Addendum/Erratum  
to

A HYDROLOGIC ANALYSIS  
OF THE  
POWERLINE F.R.S.

Flood Control District of Maricopa County  
Hydrology Division  
Watershed Management Branch

June 1989

Figure C-1  
 Areal Reduction for 100 Year Event

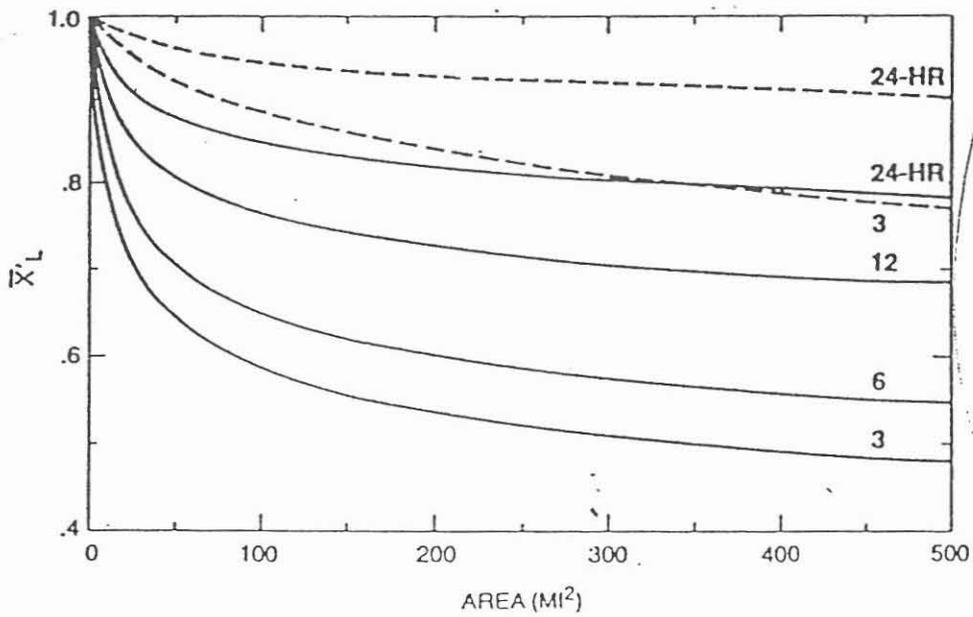
In-house discussions lead to the direction to use areal reduction in the Powerline analysis:

1. Page 9, Table 2.2, the aerial reduction ratios listed under the "Osburn method" appear to be too low for the 24-Hour Storm. We reference Figure 15, page 29 of "NOAA Technical Memorandum NWS HYDRO-4., Depth-Area Ratios in the Semi-Arid Southwest United States."

The decision was made to incorporate areal reduction using the NOAA Technical Memorandum NWS HYDRO-40: Depth-Area Ratios in the Semi-Arid Southwest United States (Reference 7). Independent determinations for the values were conducted to determine accurate ratios. The depth-area ratios, the related areas, and the precipitation depths for the Powerline F.R.S. analysis are listed below in Table 3.1. (See Figure C-1 in Appendix C for the Depth-Ratio Curve).

Figure D-1  
 Area & Capacity Curves - Powerline F.R.S.

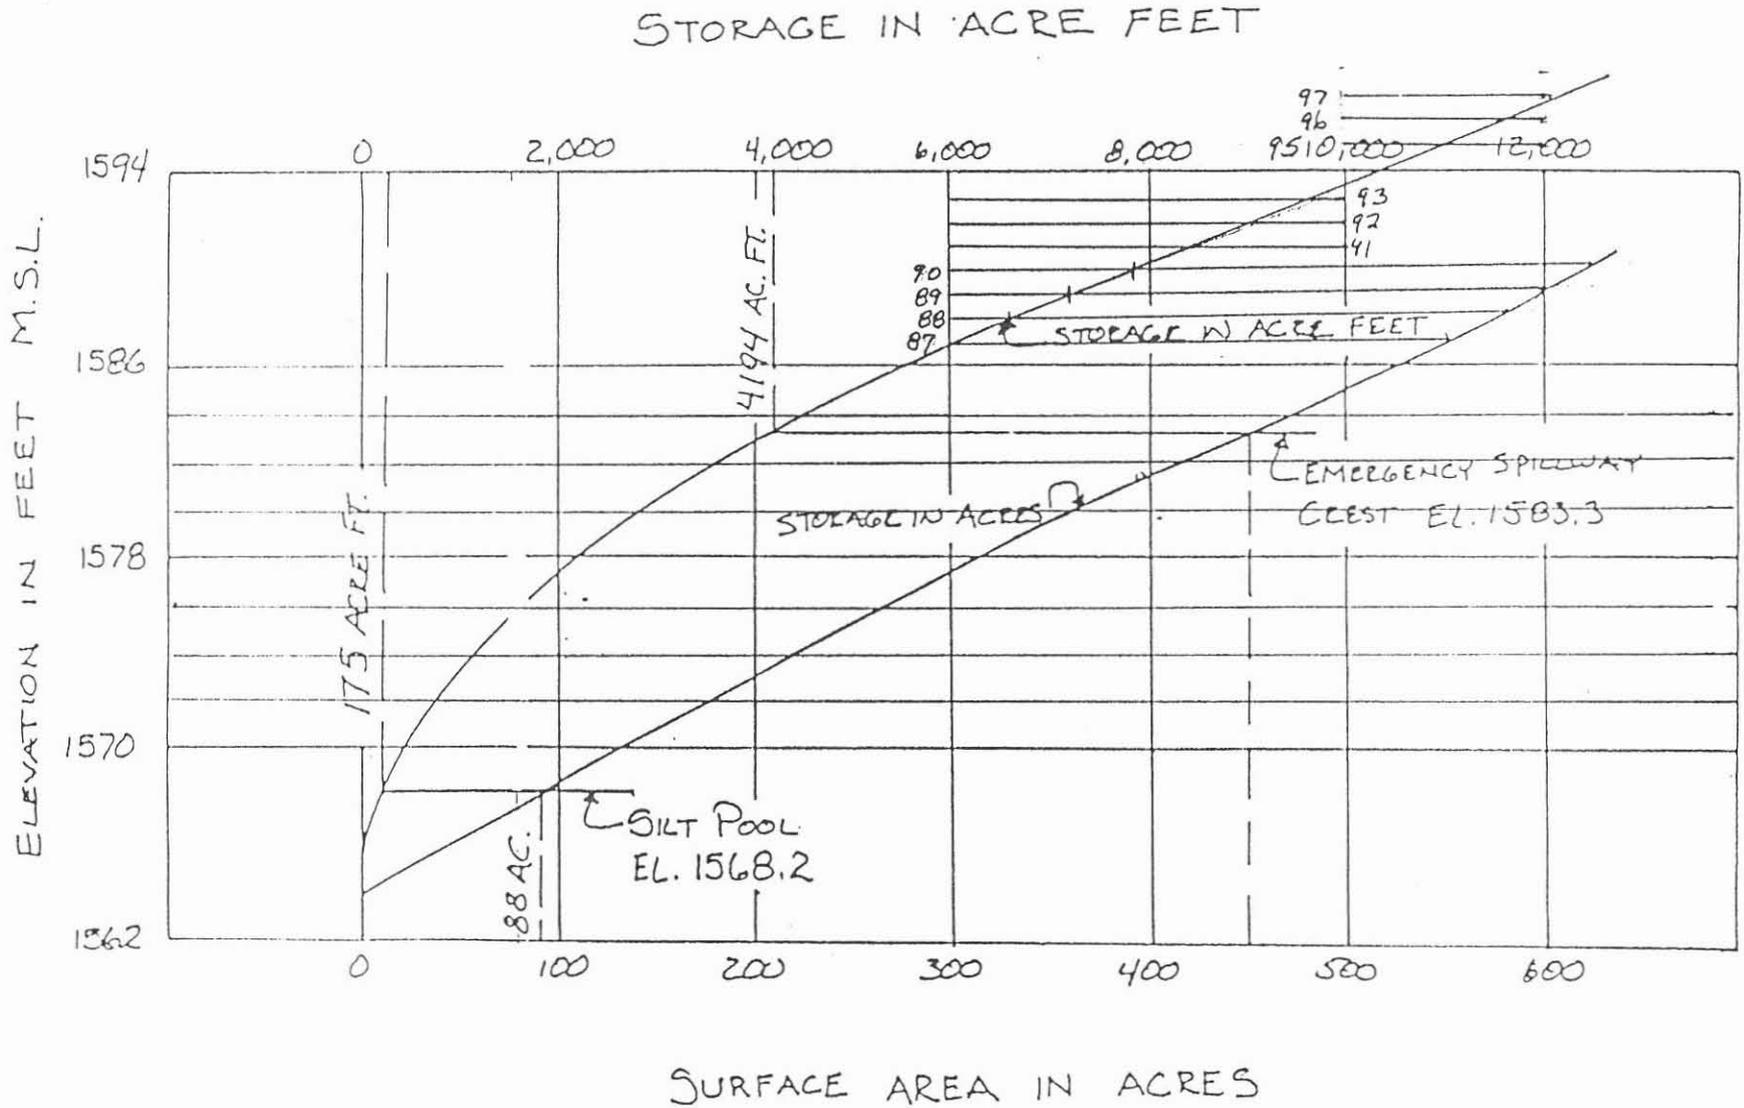
Where did the stage-storage rating curve for the Powerline spillway originate and was it validated?

In the original analysis, an error was detected in the estimated storage volume for 1590.6 feet amsl, which caused an error in the estimate of the increase of height in the dam to retain the full PMF without overtopping of the structure. To correct the error, the Area & Capacity curve for Powerline F.R.S. found in the FCD's Structures Book was used to extrapolate storage volumes over the height of the structure. (See Figure D-1 in Appendix D for the rating curve).

The stage-storage rating curve for the Powerline F.R.S. spillways up to the elevation of 1590.1 feet amsl was taken from the 1985, SCS Weekes Wash Study (Reference 5). The values were verified against the "Area and Capacity Curve for Powerline F.R.S." found in the Flood Control District's (FCD) Structures Book (Reference 3) (See Figure D-1 of Appendix D for the curves) and found to be accurate.

Correcting the rating curve resulted in an increase of the proposed height (5 feet) in which the structure would need to be raised in order to alleviate overtopping of the structure by the full PMF.
